AEP:NRC:0538

PROPOSED TECHNICAL SPECIFICATION CHANGE

D. C. COOK - UNIT 1

Figure 3.2.3a

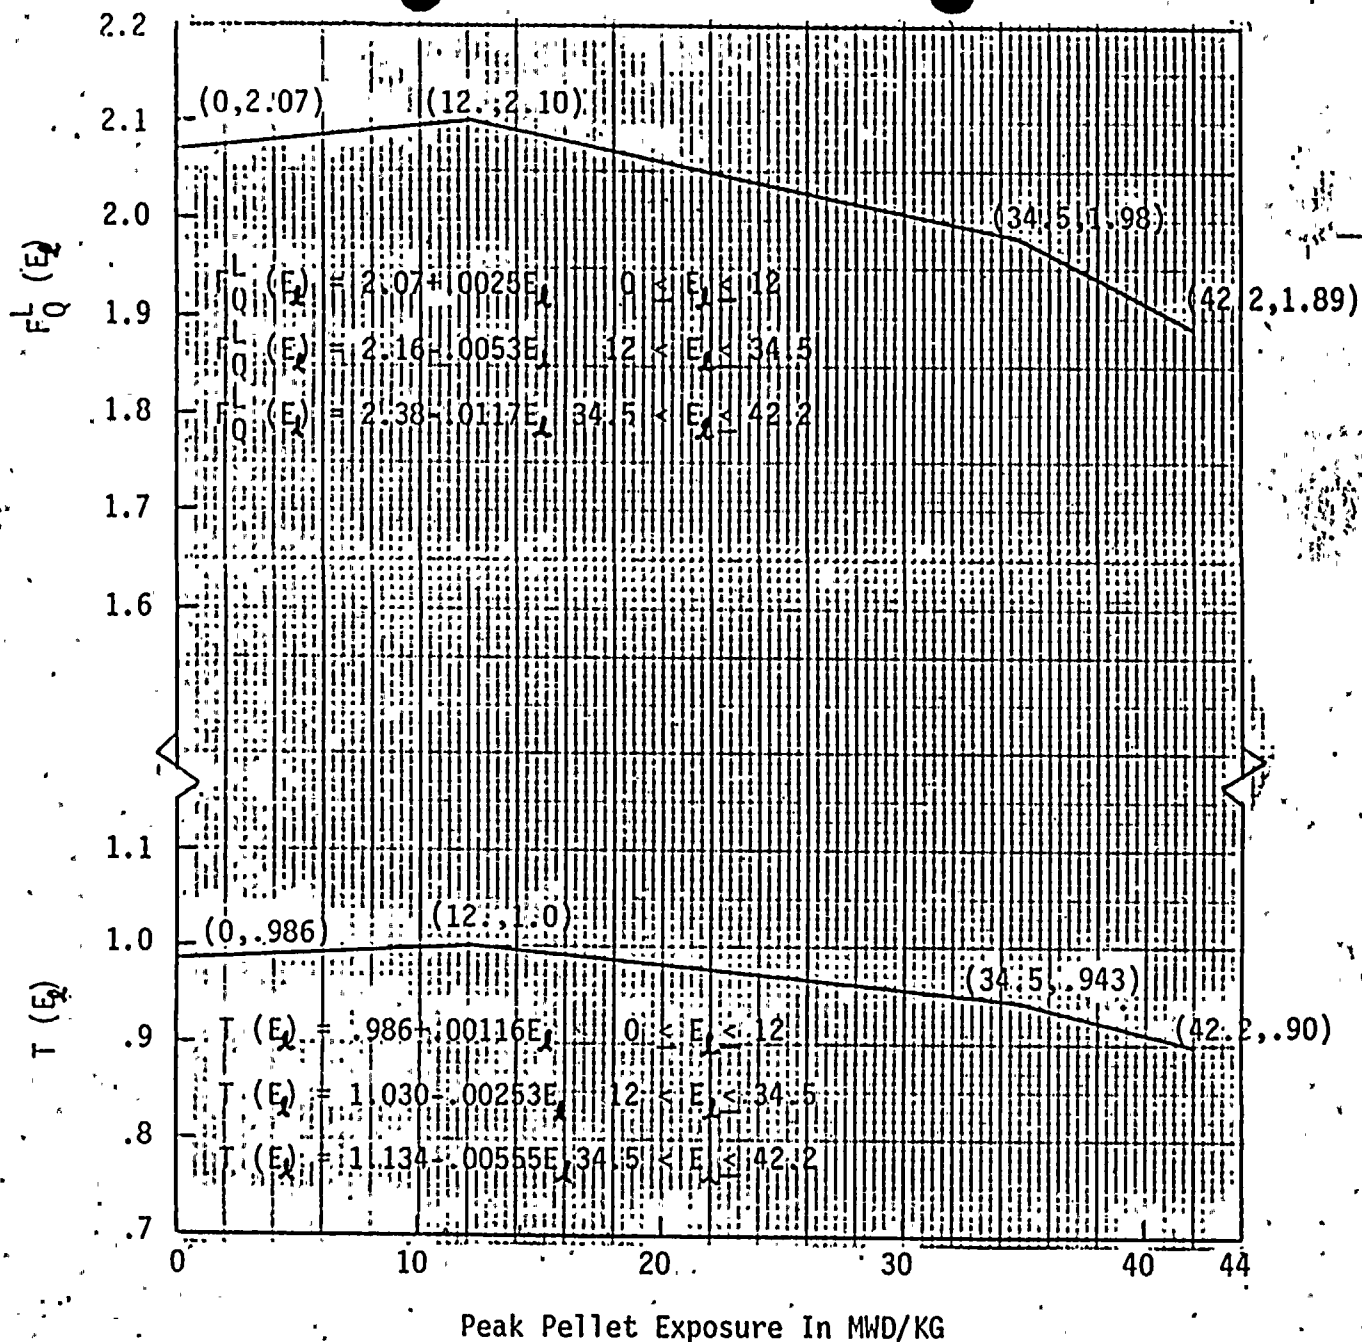
1. The proposed revisions indicated by vertical lines in the right margin of pages 3/4 2-6,15,16,19,20 and B 3/4 2-2 are changes related to the new FQ limits.
2. The proposed revisions indicated on pages 3/4 2-3 and 2-17 are editorial changes to the existing Technical Specifications which rectify conflicts between certain peaking factor surveillance requirements. They are being submitted at this time for convenience since they involve the same Technical Specification sections as the changes discussed in 1 above.

Exposure Dependent F_Q Limit, $F_Q^L(E_p)$, and Normalized Limit $T(E_p)$ as a Function of Peak Pellet Burnup for Exxon Nuclear Company Fuel.
